Access Compliance Report Public Rights-of-Way (Curb Ramps)

Main Street: RANUNCULUS_ST		Cross Street: SHIVELY_RD		Location:	S
ADA ID: RPRK211111114649	Ramp Type: Type 4 - Parallel	Initial Pass/Fail: Fail	Overall Compliance: No	Severity Score:	30

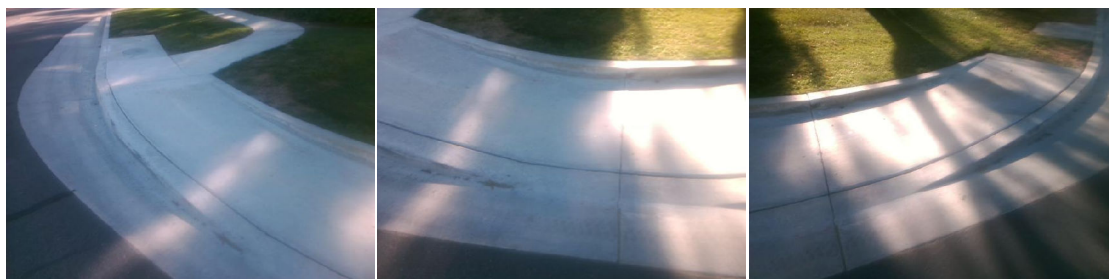
Compliance	Description	Data	Compliance	Description	Data
N/A	Ramp Length LT (in)	132	N/A	Ramp Length RT (in)	137
Yes	Ramp Width LT (in)	53	Yes	Ramp Width RT (in)	53
No	Ramp Run Slope LT (%)	13.4	Yes	Ramp Run Slope RT (%)	0.3
Yes	Ramp Cross Slope LT (%)	0.5	Yes	Ramp Cross Slope RT (%)	0.3
N/A	Landing Present	N/A	N/A	DWS Provided	N/A
N/A	Landing Length (in)	N/A	N/A	DWS Contrast	N/A
N/A	Landing Width (in)	N/A	N/A	DWS Length (in)	N/A
N/A	Landing Run Slope (%)	N/A	N/A	DWS Full Width	N/A
N/A	Landing Cross Slope (%)	N/A		DWS Offset Type	N/A
N/A	Landing Movement Obstructed?	N/A	N/A	DWS Offset Left (in)	N/A
	Landing Movement Type	N/A	N/A	DWS Offset Right (in)	N/A
N/A	Landing Shared	N/A			
N/A	Clear Space	Yes			
N/A	Clear Space To Crosswalk (in)	N/A			
N/A	Marked Crosswalk 1	No	N/A	Marked Crosswalk 2	No
	Crossing 1 Direction	NE		Crossing 2 Direction	NW
	Marked Crosswalk 1 Width (in)	N/A		Marked Crosswalk 2 Width (in)	N/A

Remove & Replace Curb Ramp With Two New Directional Ramps or Equivalent.
